STATE OF NORTH CAROLINA
DEPARTMENT OF TRANSPORTATION

ADDENDUM # 2

RE: **Contract Time & Plan Sheet Revision**
Contract ID: DN00281
County: Macon
Letting Date: May 11, 2021

DATE PRINTED: 5/5/2021 6:03:02 PM
\$FILEL\$
\$PENTBLS\$

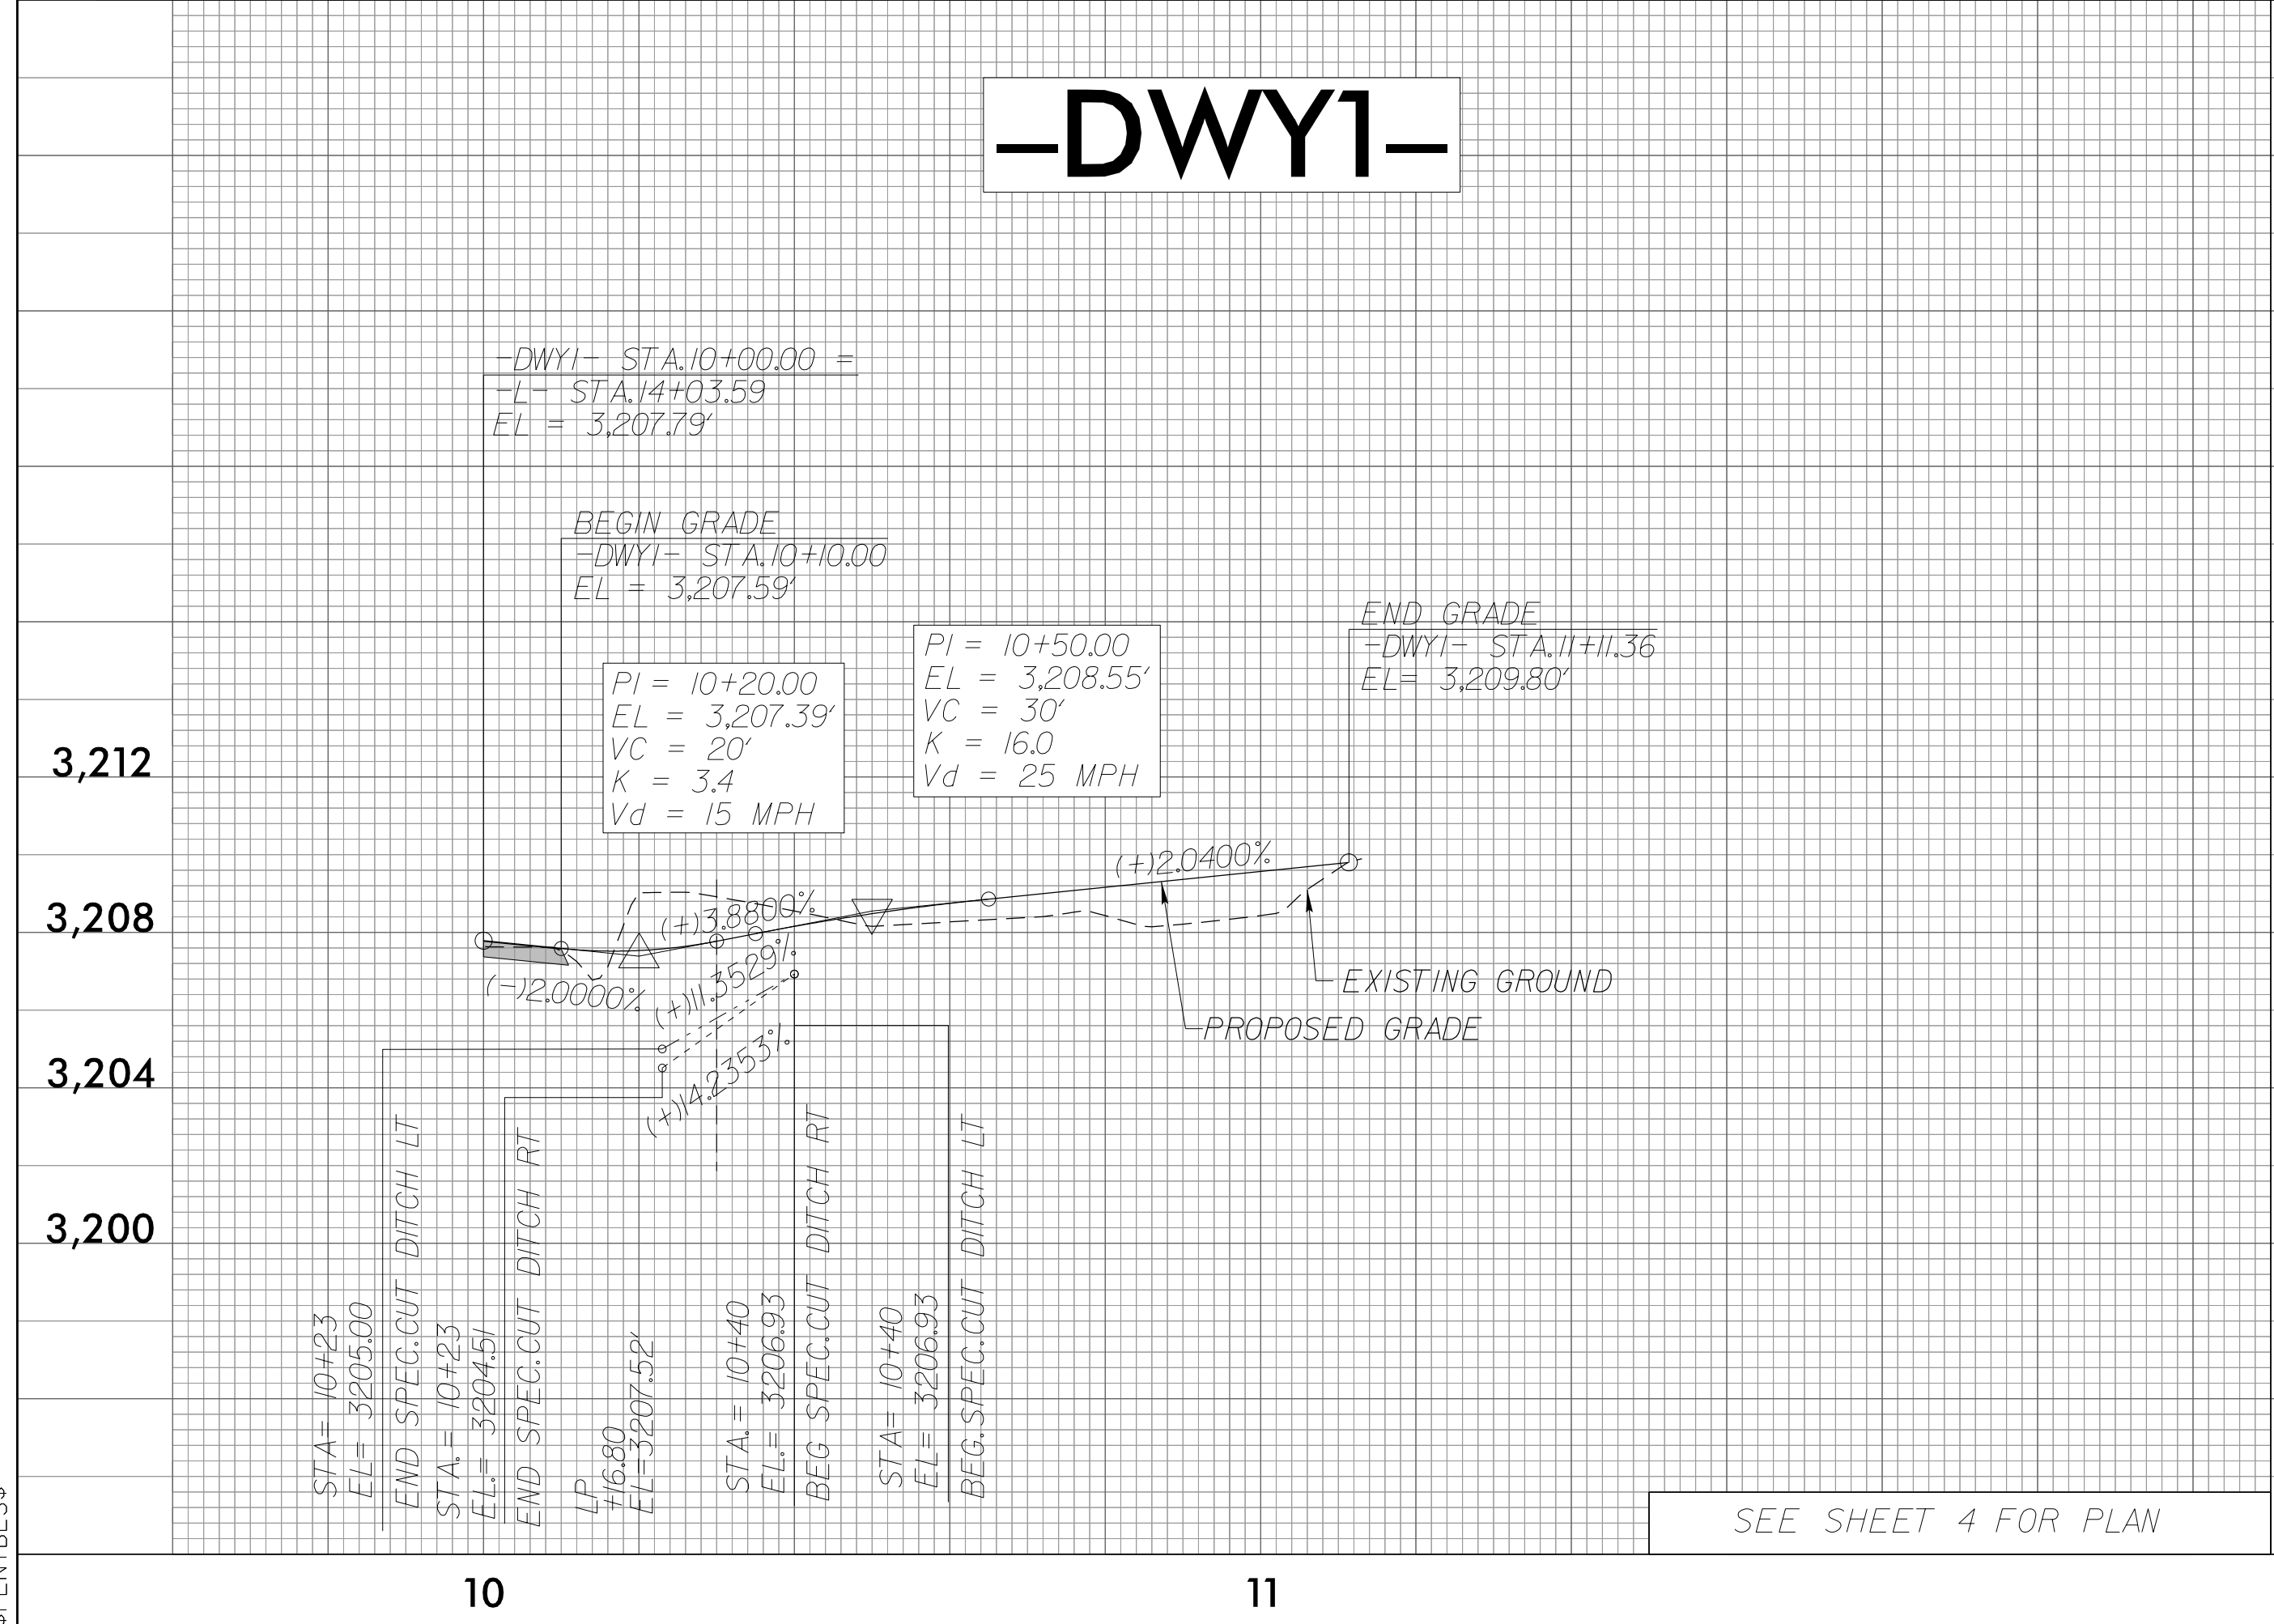
On sheet no. 5 of the DN00281 – STANDARD PDF PLANS – ROADWAY, there is a note stating that the 11'-5" x 7'-1" arch pipe will be provided by the NCDOT. This is incorrect. The arch pipe will be provided by contractor.

See attached revised sheet no. 5 showing this correction.
